# City of Corpus Christi

## Meeting Agenda Planning Commission

Wednesday, September 1, 2021

**TECHNICAL REVIEW PLAT REQUIREMENTS  
REGULAR PLANNING COMMISSION MEETING  
September 1, 2021**

PARK BLOCK  
OCEAN VIEW ADDITION  
VOLUME 39, PAGE 29  
M. R., N. Co., TX.

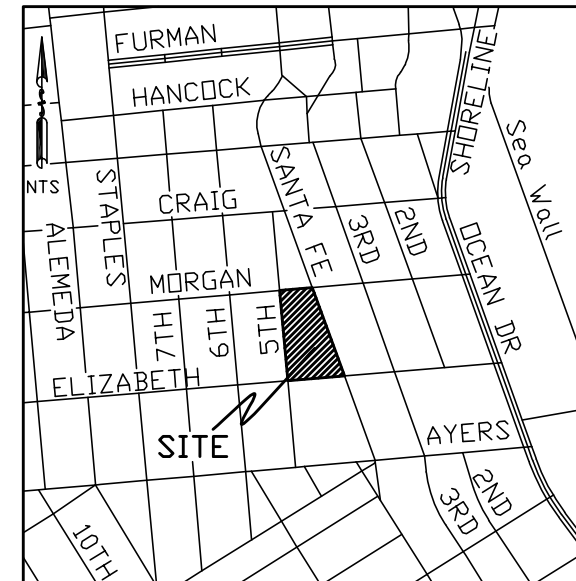
GIS					
No.	Sheet	Comment	Applicant Response	Staff Resolution	Applicant Response
1	Plat	Plat closes to acceptable engineering standards. (TSPS Manual of Practice Appendix A, Condition 3; Suburban Traverse Error of Closure)	Understood		
2	Plat	Pls include tracts 2 and 3 in general description of lots being platted. Refer to doc #2017055057 DRNCT. (tax id #'s 598300130075 and 598300130070)	Understood	Resolved.	
3	Plat	Elizabeth Street suffix is "Street" and not Avenue. Pls revise.	Revised	Resolved.

LAND DEVELOPMENT					
No.	Sheet	Comment	Applicant Response	Staff Resolution	Applicant Response
1	Plat	Update the owner's signature certificate/block with the owner as named/listed in the application and support documents.	Revised	Revise to say: Parlapalli Family Partnership, LTD certifies that it is the owner of the foregoing plat, that it has had said land surveyed as shown, and that this map was made for the purpose of description and dedication. This ____ day of ____, 20__.  Sunil P. Reddy, Managing Member of SPRG Property management, as General Partner of Parlapalli Family Partnership, LTD.	Revised per request
2	Plat	Include the subdivision's name, block and lot numbers in the owner's signature certificate/block.	Revised	Resolved.	
3	Plat	Update the city engineer's signature certificate/block to read Development Services Engineer.	Revised	Resolved.	
4	Plat	Update the Development Services Department's signature certificate/block to "... approved by the Planning Commission"	Revised	Resolved.

5	Plat	Update line type delineating properties east of Santa Fe	Revised	Resolved.	
6	Plat	Show easements and dimensions of surrounding lots shown on drawings.	Revised	Resolved.	
7	Plat	Update your sheet title to read " Being a replat..."	Revised	Resolved.	
8	Plat	See GIS comment No.2	Revised	Resolved.

FINAL PLAT

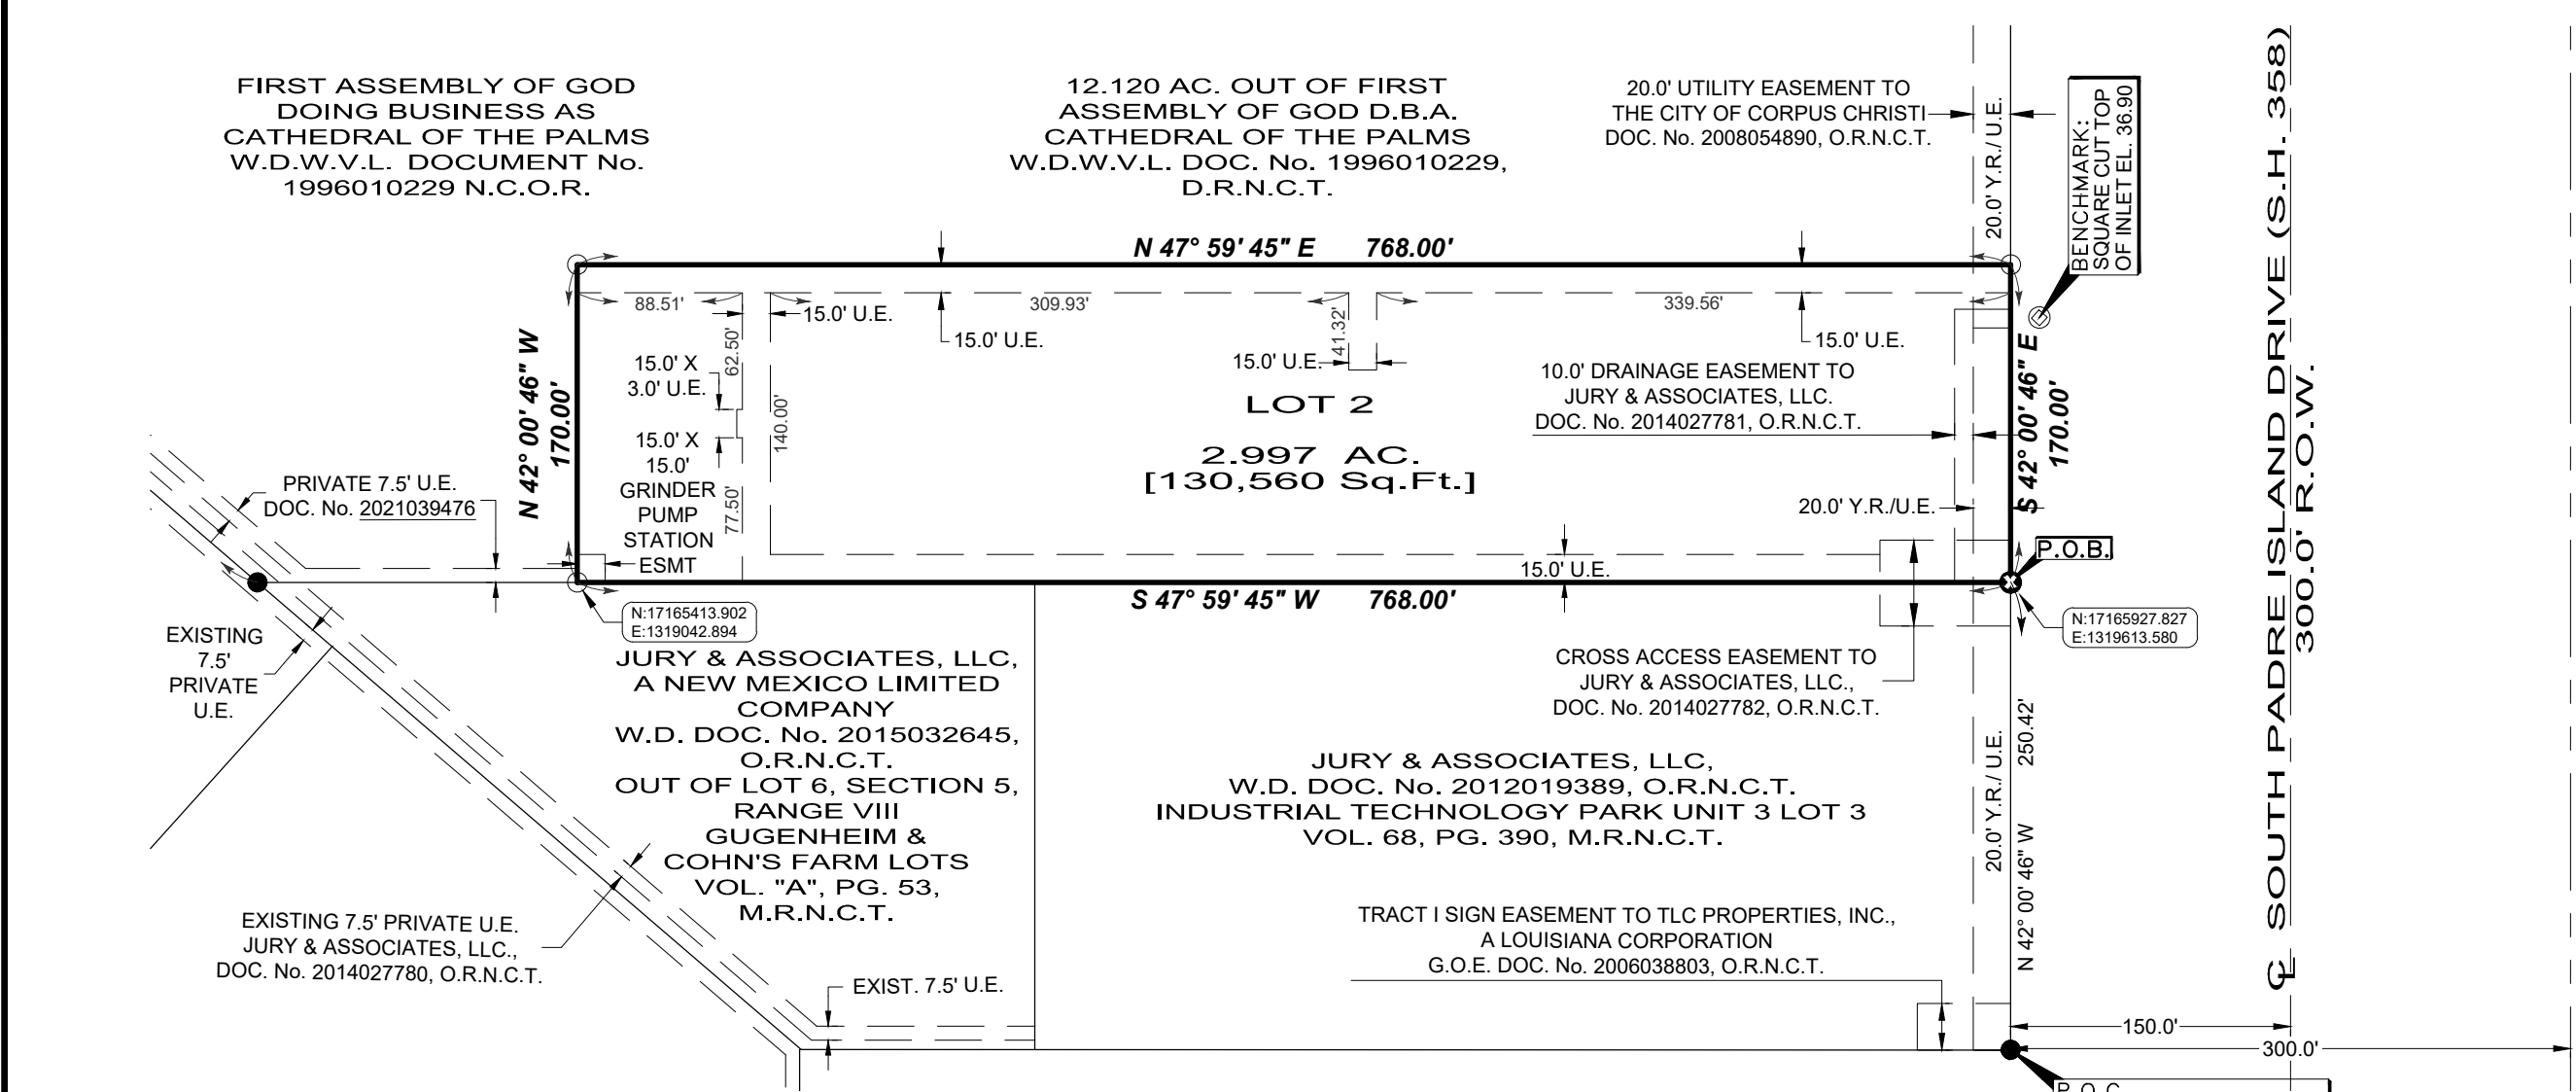
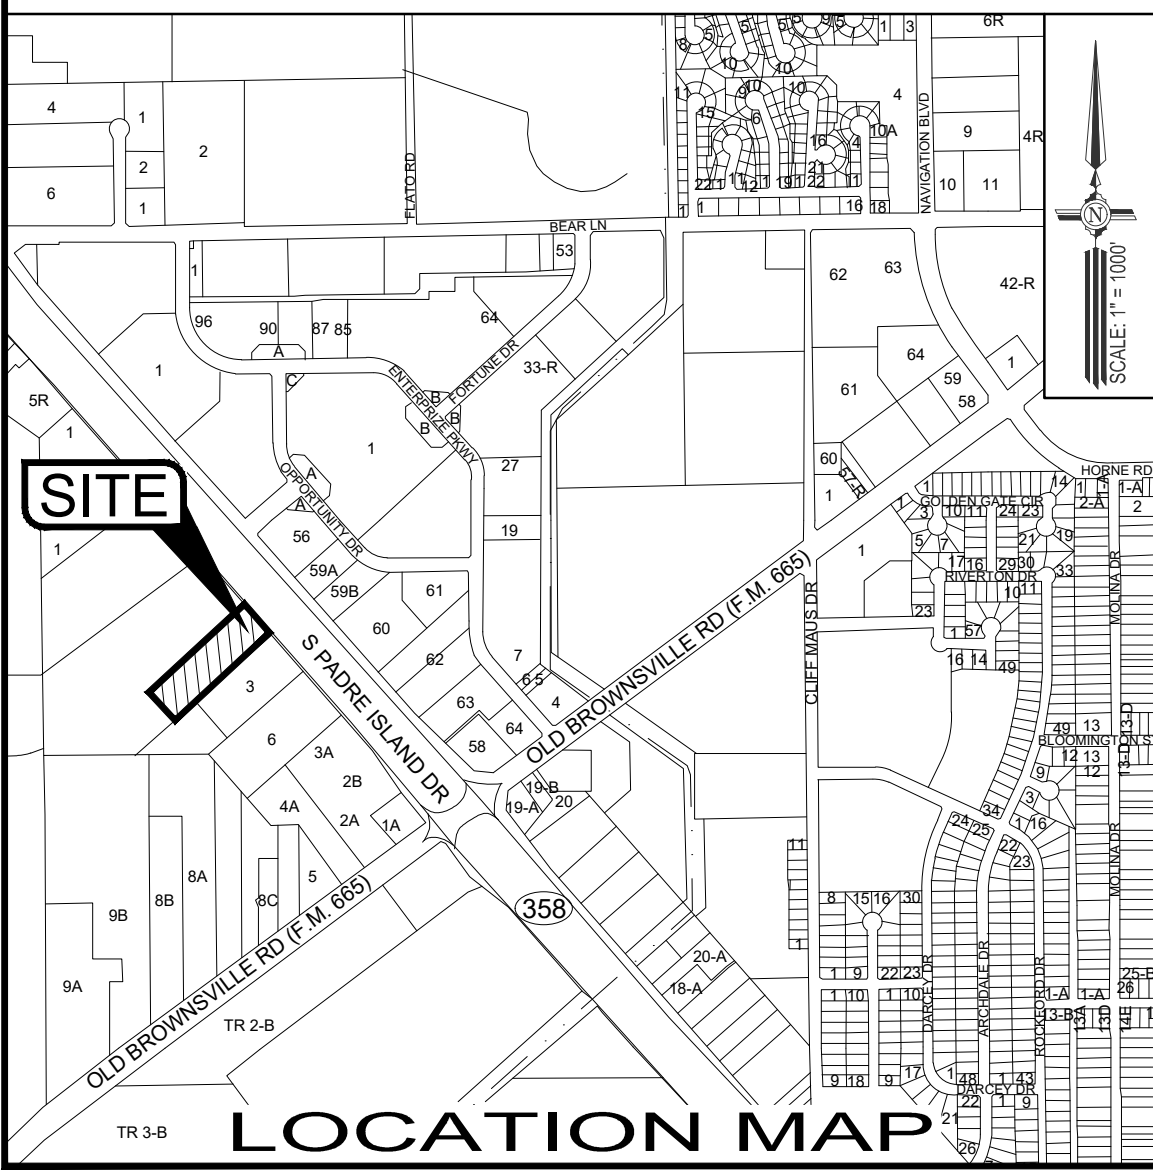
GIS						
No.	Sheet	Comment	Applicant Response	Staff Resolution	Applicant Response	Staff Resolution
1	Plat	The plat closes within acceptable engineering standards. (TSPS Manual of Practice Appendix A, Condition 3; Suburban Traverse Error of Closure)	OK			
2	Plat	Please remove duplicate legal description SW of platted area. (UDC 8.2)	WE'VE UPDATED THE OWNERSHIP	Resolved.		
3	Plat	Revise SE adjacent lot document number on utility plan. (TSPS Manual of Practice Category 1B, 4.H)	DONE	Resolved.

LAND DEVELOPMENT						
No.	Sheet	Comment	Applicant Response	Staff Resolution	Applicant Response	Staff Resolution
1	Plat	Revise the legal description under the plat title to read: "Being a 2.997 acres out of..."	DONE	Addressed		
2	Plat	On the owners certificate block; underneath Alicia Rodriguez remove only the address information and label her signature title.	DONE	Addressed		
3	Plat	On the Planning Commission certificate block change "Carl Crull, P.E." with Jeremy Baugh"	DONE	Addressed		
4	Plat	On the Engineering certificate block change "Pablo Martinez P.E." to " "Brett Flint, P.E."	DONE	Addressed		
5	Plat	Prior to plat recordation show and label private 7.5' U.E Doc No.	DONE	Addressed		
6	Plat	Water Distribution System acreage fee – 3.0 acres x \$1,439.00/acre = <b>\$4,317.00</b>	OWNER WILL PAY	Prior to plat recordation		
7	Plat	Wastewater System acreage fee – 3.0 acres x \$1,571.00/acre = <b>\$4,713.00</b>	OWNER WILL PAY	Prior to plat recordation

DEVELOPMENT SERVICES ENGINEERING						
No.	Sheet	Comment	Applicant Response	Staff Resolution	Applicant Response	Staff Resolution
1	Plat	Development on this site shall manage storm water drainage caused by the development of the property, drainage directed to the property by ultimate development, and drainage naturally flowing onto and through the property per UDC 8.2.8.B.2	<b>OK</b>	Addressed		
2	Plat	Public Improvements Plans are required; submit a .PDF copy of proposed Public Improvements along with a title sheet to Publicimprovments@CCTexas.com for review and approval prior to Final Plat Recordation, UDC 8.1.3.A	<b>SENT 4/21/2021</b>	Addressed		
3	Plat	Access and drainage into the TxDOT Right-of-Way on South Padre Island Drive will require review and approval by TxDOT. Provide a copy of the TxDOT approval to the City of Corpus Christi, Development Services.	<b>SENT 4/21/2021</b>	Addressed

4	Utility Plan	Notes and text on the plan at the property frontage on Padre Island Drive are overlapping and unreadable. Please provide a second sheet or inset enlargement of this area.	<b>DONE</b>	Addressed		
5	Utility Plan	If a Reimbursement Agreement is requested, this agreement must be complete and approved by City Council prior to the start of Construction.	<b>N/A</b>	Addressed		
6	SWQMP	Provide a drainage plan showing contours, elevations and existing and proposed drainage flow direction, include offsite contributions.	<b>SEE SHEET 13</b>	Addressed		
7	SWQMP	Provide locations and cross sections of proposed Detention ponds and show flow direction to the ponds and to the TxDOT outfall. (UDC 8.2.8 and Municipal Code 14.1002 and 14.1003)	<b>SEE SHEET 13</b>	Addressed		
8	SWQMP	Provide anticipated flows at the Proposed outfall and the calculated outfall capacity.(UDC 8.2.8 and Municipal Code 14.1002 and 14.1003)	<b>SEE SHEET 13</b>	Addressed

1	Plat	Add Notes on Plat Sheet 1; 1)No additional access onto SH 358. Access location to SH 358 will be as graphically shown on this Plat. 2)Any storm drainage discharge to State of Texas right-of-way shall be reviewed and approved by TxDOT.	DONE	Addressed		
---	------	--	------	-----------	--	--

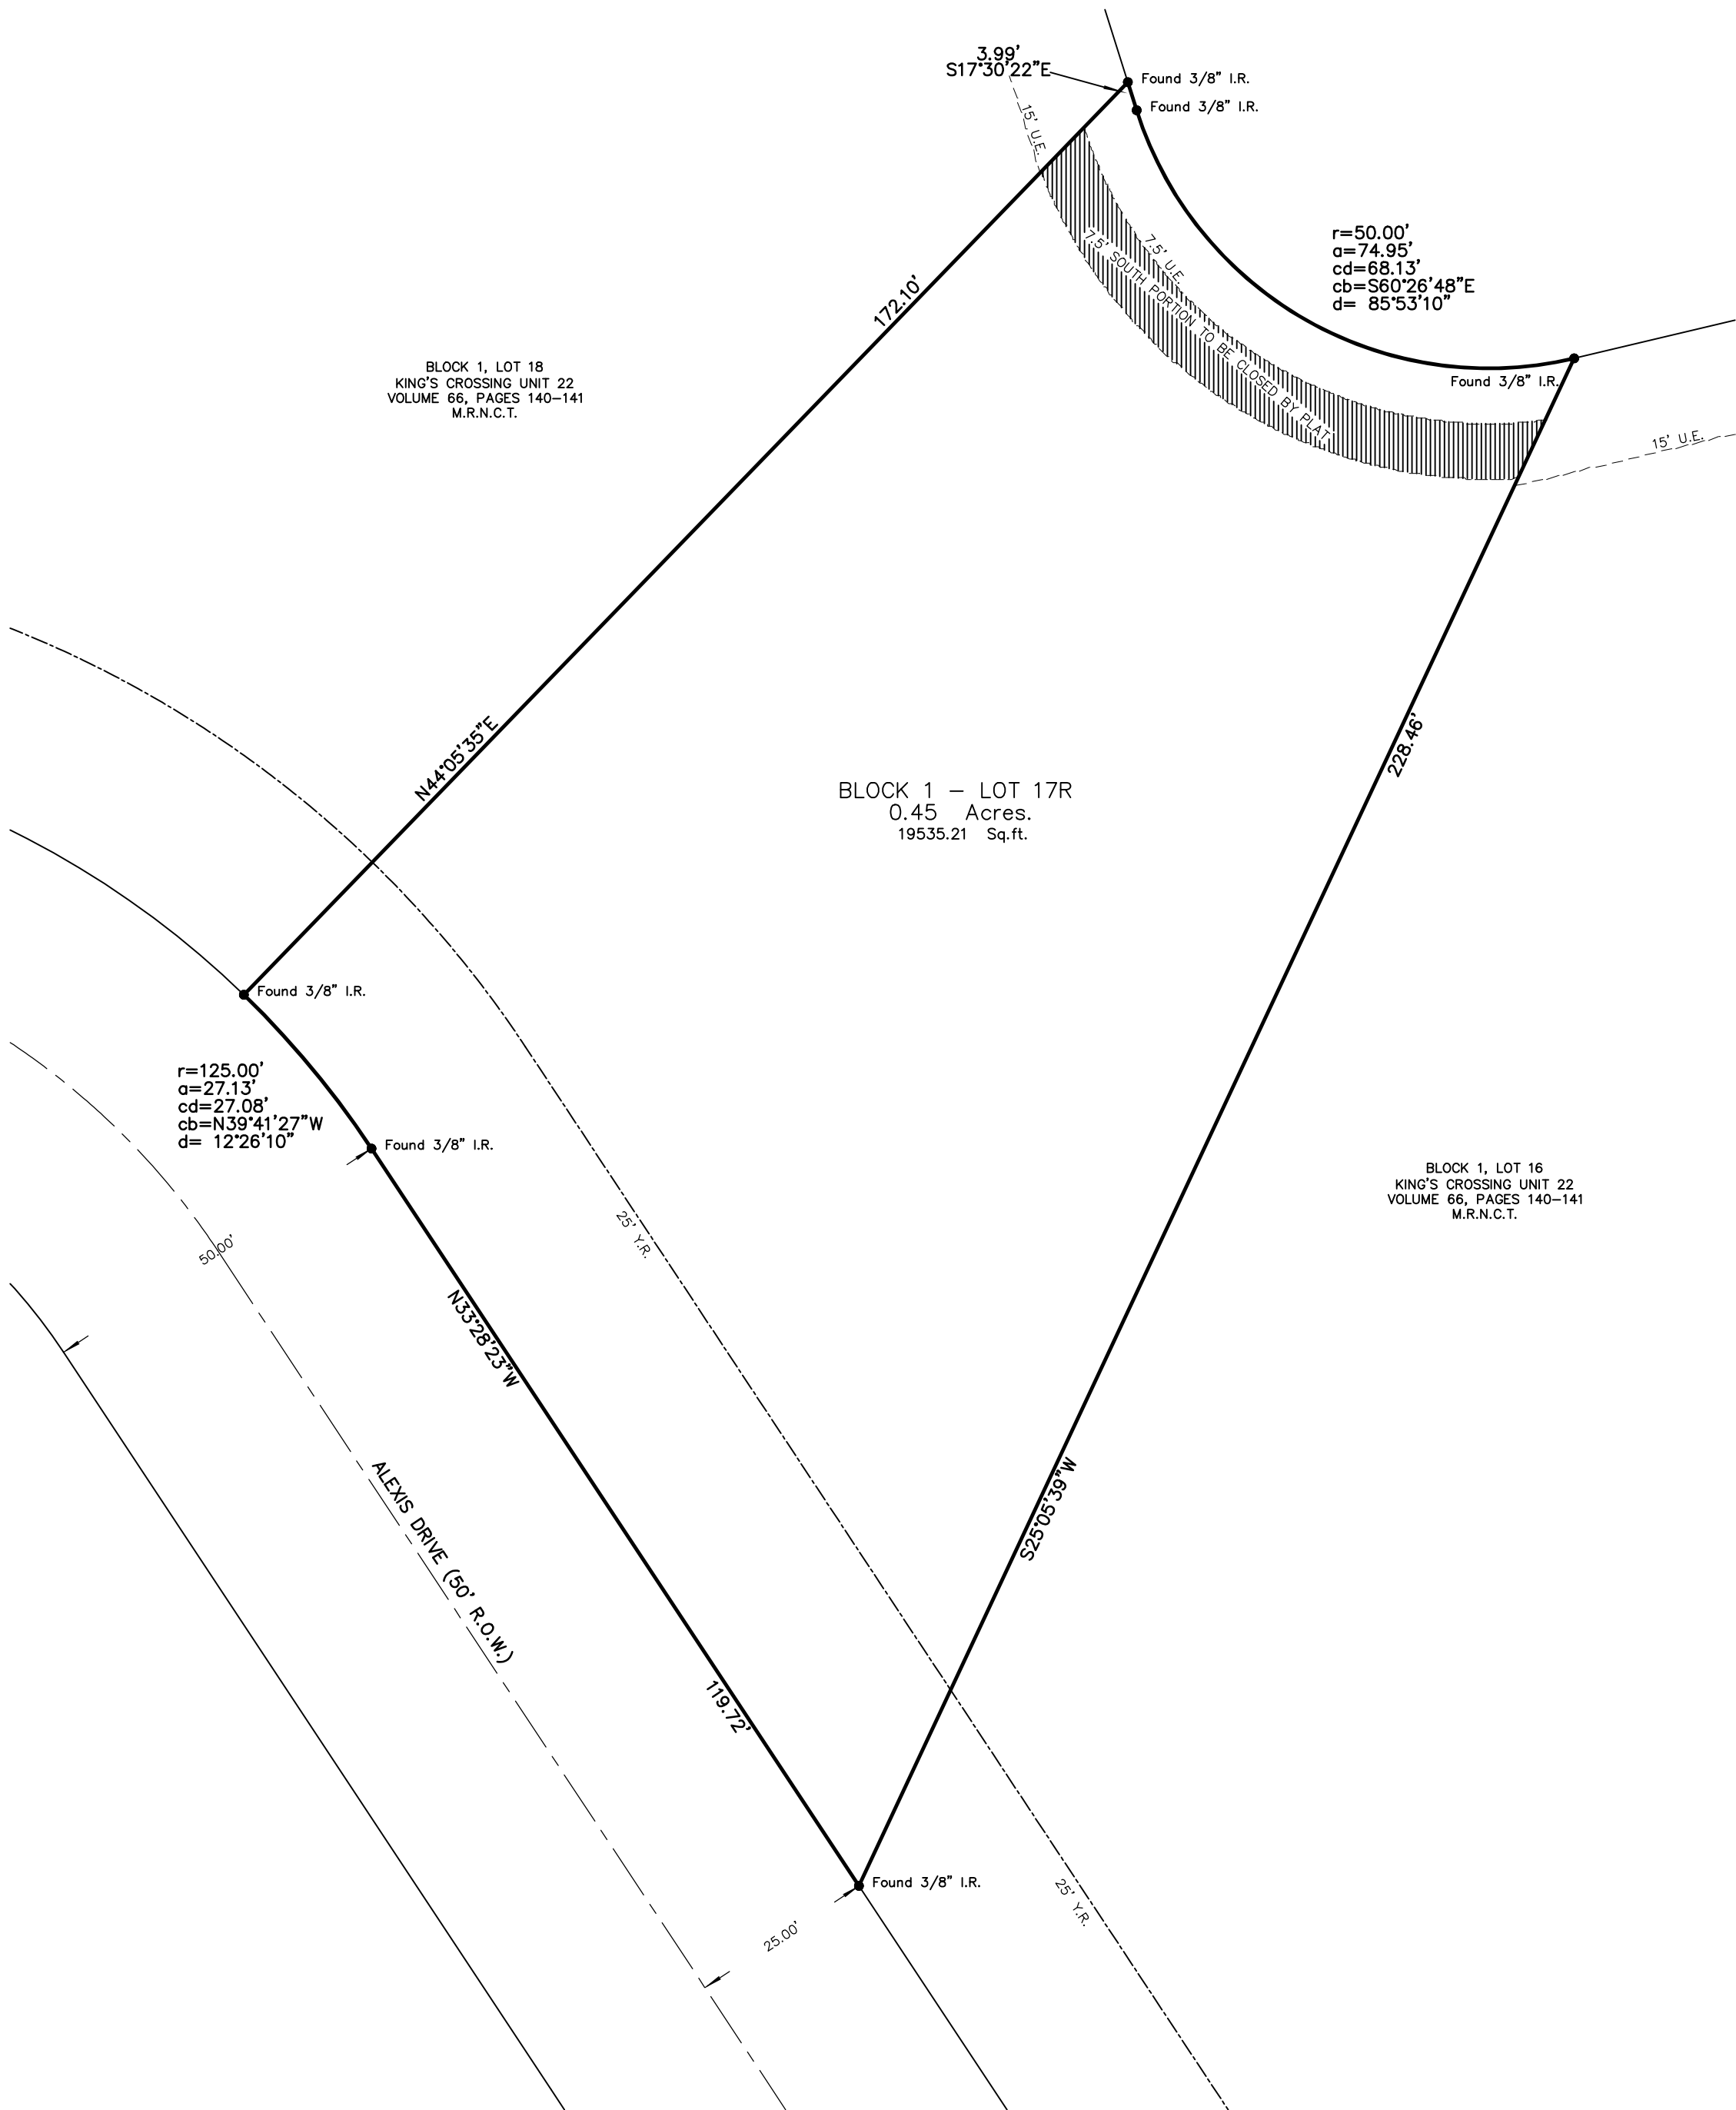
GIS						
No.	Sheet	Comment	Applicant Response	Staff Resolution	Applicant Response	Staff Resolution
1	Plat	Location Map does not provide adequate context for locating platted area. Pls revise.	DONE	Addressed		
2	Plat	Correct general description to indicate the lot being re-platted is 17 not 17R.	DONE	Addressed

No.	Sheet	Comment	Applicant Response	Staff Resolution	Applicant Response	Staff Resolution
1	Plat	On plat title correct to "Lot 17R"	DONE	Addressed		
2	Plat	On plat description, update previous lot number to "Lot 17"	DONE	Addressed		
3	Plat	Provide a Planning Commission certificate with Al Raymond III, AIA as Secretary and Jeremy Baugh as Chairman.	DONE	Addressed		
4	Plat	Update location map to include a major street such as Cimarron Boulevard.	DONE	Addressed		
5	Plat	Show previous 15' UE boundary with hatch. Provide a leader note indicating, "7.5' south portion to be closed by plat".	DONE	Not addressed.	DONE	Addressed
